## **Installation Note**

**Agilent Technologies**  
**8514A/B, 8515A,**  
**8517A/B, 85110A/L**  
**Test Set DC Return Upgrade Kits**

**Manufacturing Part Number: 08510-90504**

**Figure 1-1. HP 08510-60119 D.C. Return Upgrade Kit.**

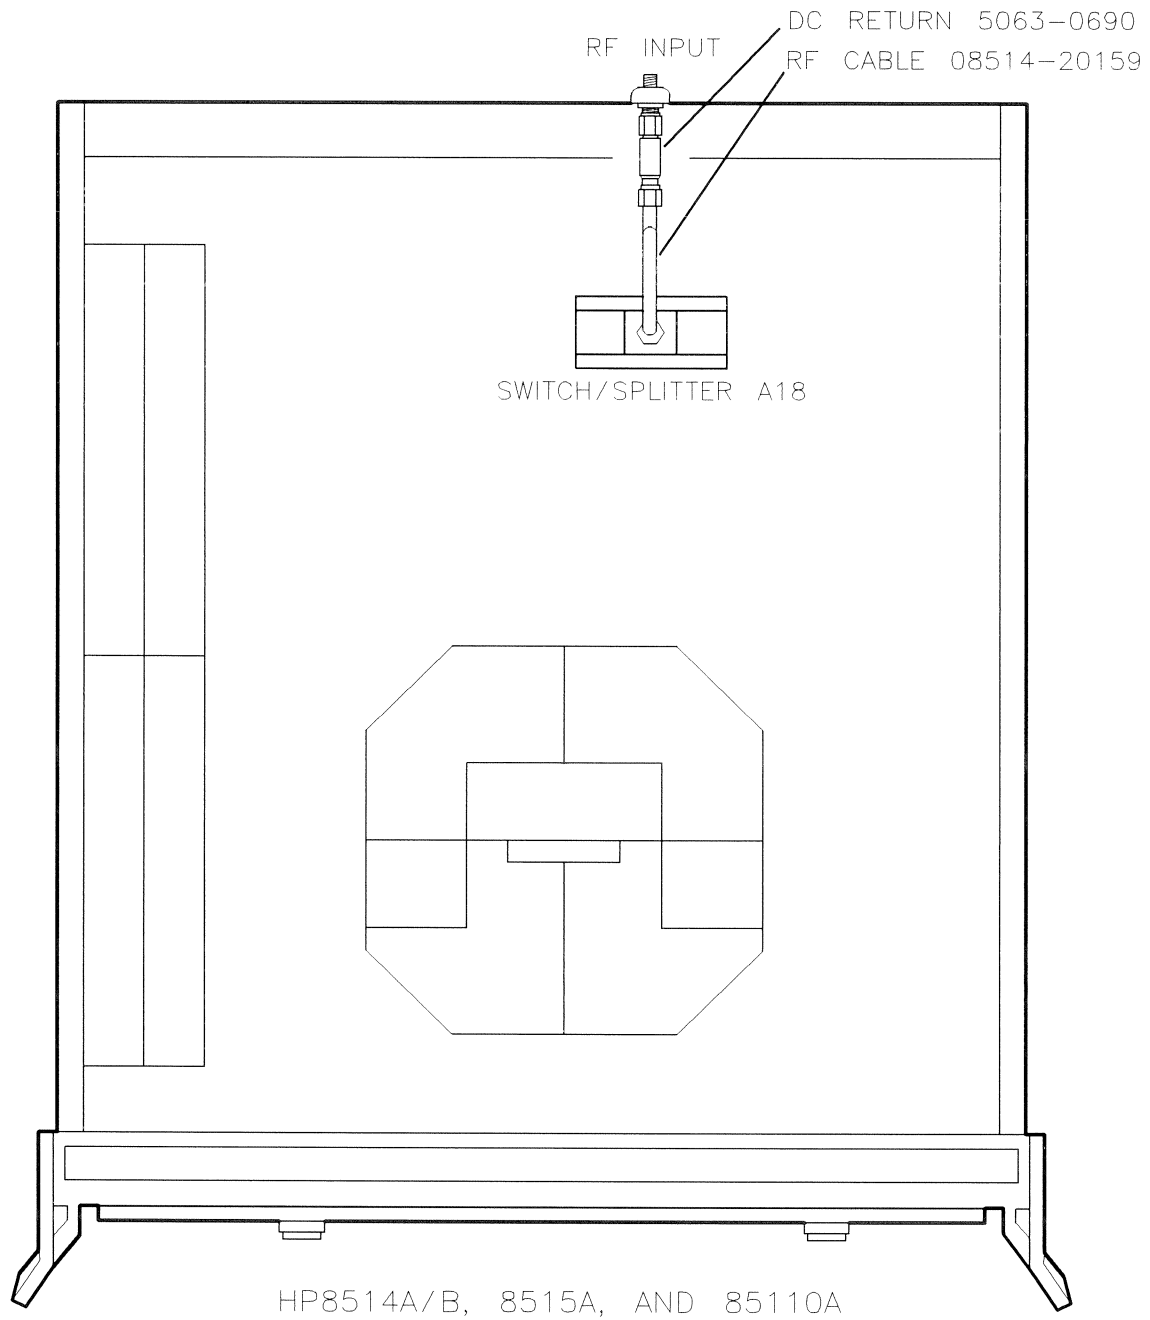
1. Remove old RF input cable going from RF input connector to switch/splitter, A18.  
Replace with cable and D.C. return as shown.

**Figure 1-2. HP 08510-60122 D.C. Return Upgrade Kit.**

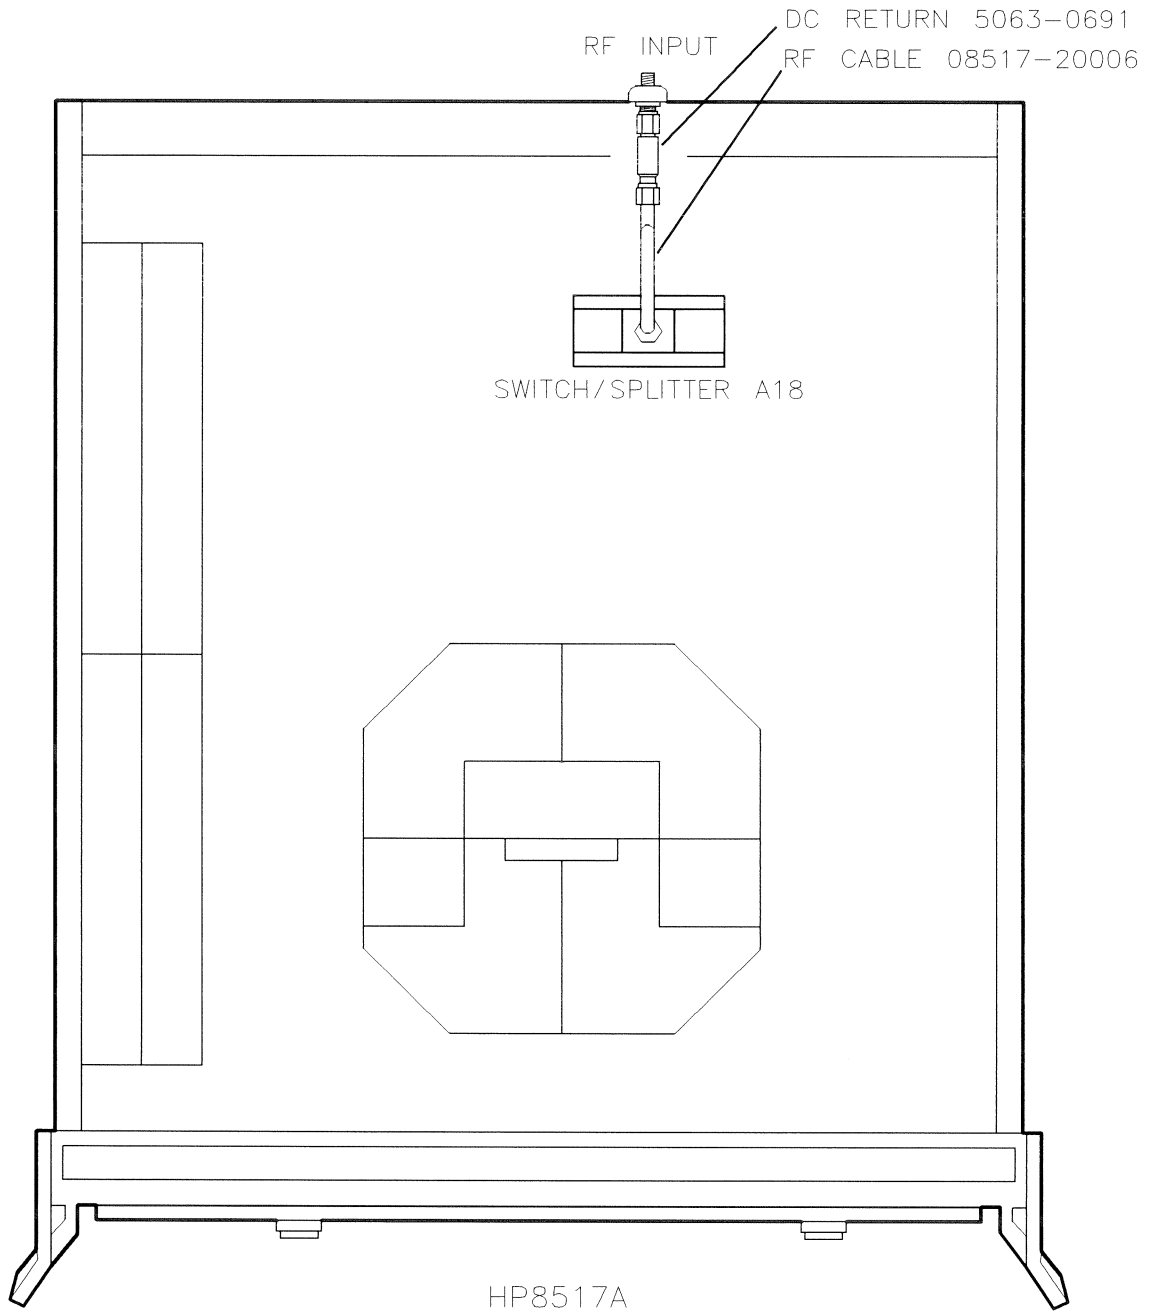
1. Remove old RF input cable going from RF input connector to switch/splitter, A18. Replace with cable and D.C. return as shown.

**Figure 1-3. HP 08510-60118 D.C. Return Upgrade Kit.**

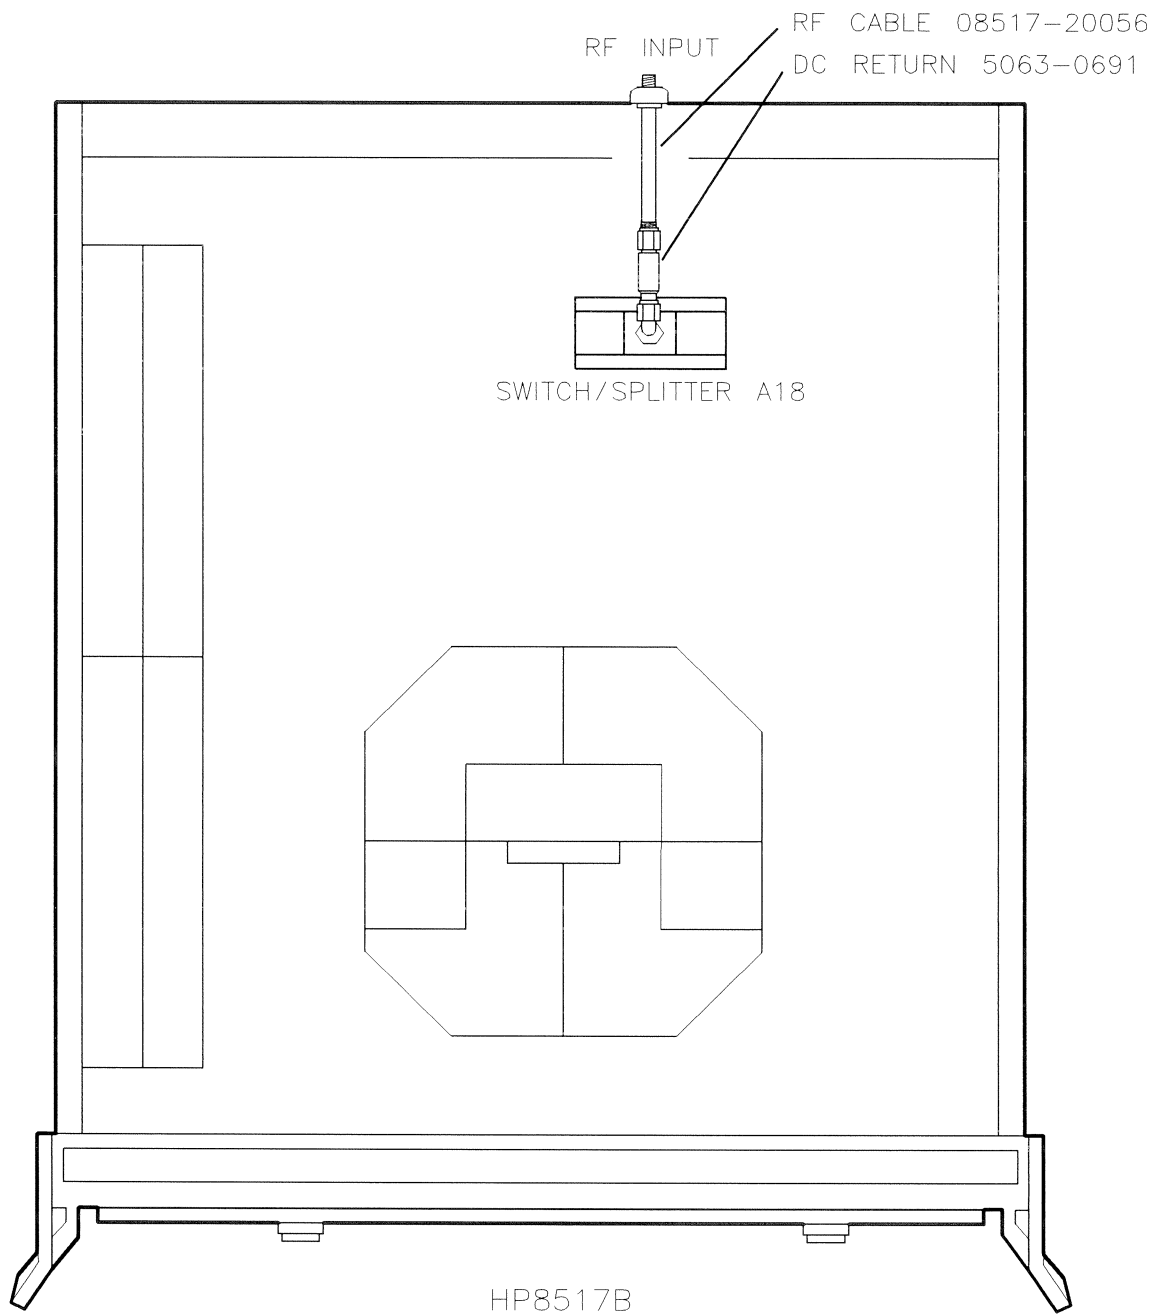
1. Remove old RF input cable going from RF input connector to switch/splitter, A18. Replace with cable and D.C. return as shown.

**Figure 1-4. HP 08510-60121 D.C. Return Upgrade Kit.**

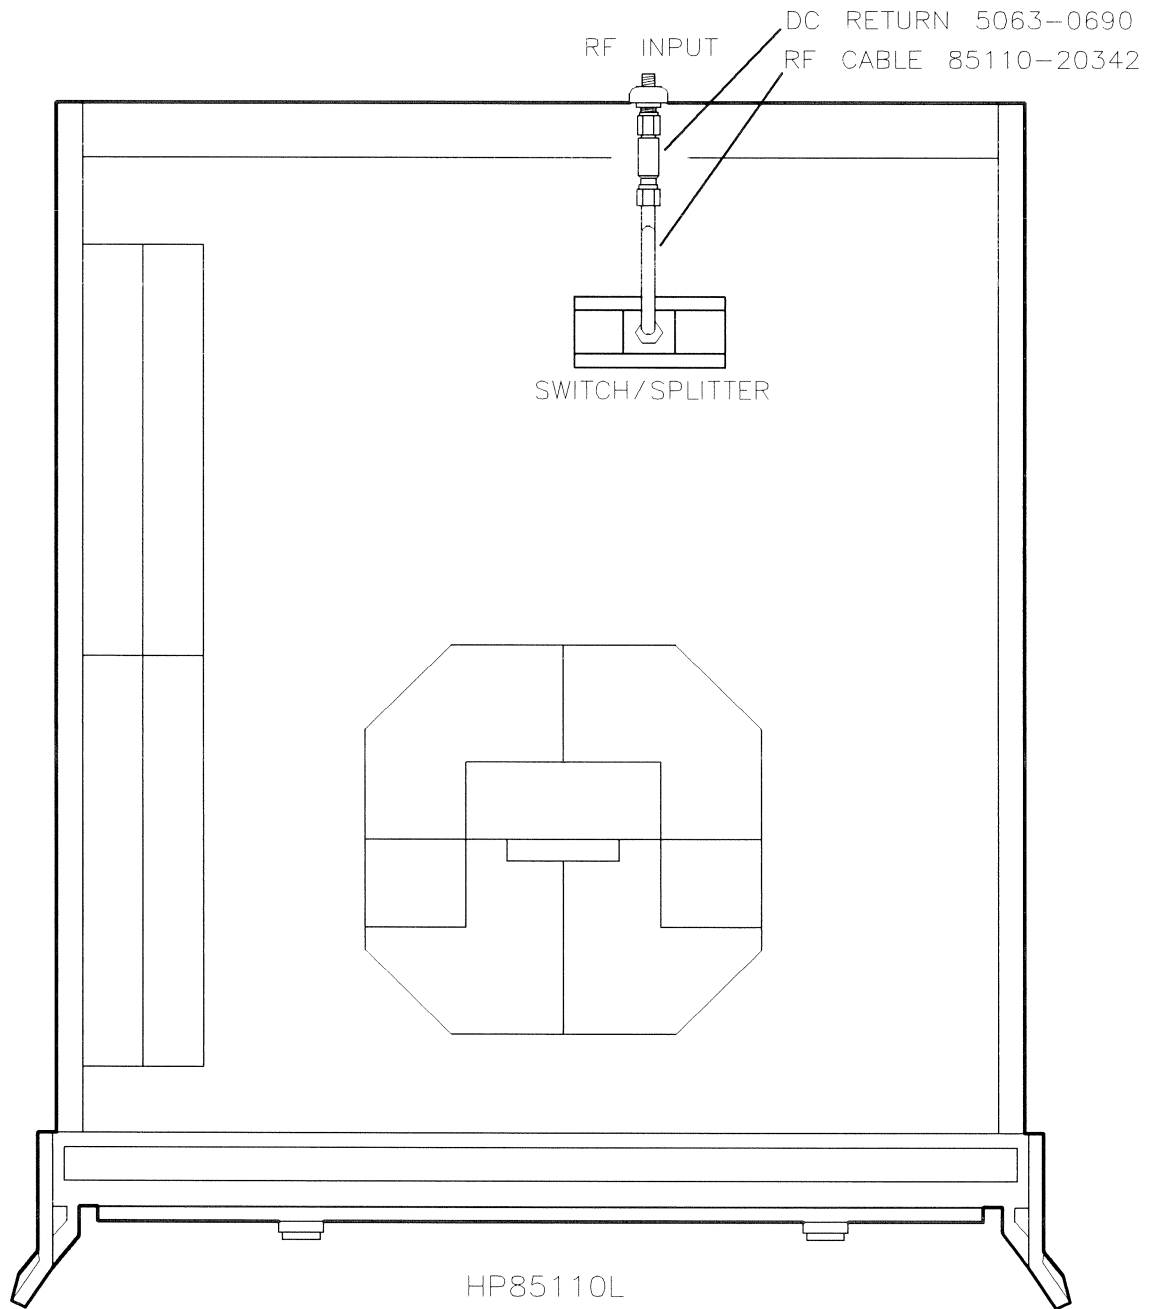
1. Remove old RF input cable going from RF input connector to switch/splitter, A18.  
Replace with cable and D.C. return as shown.
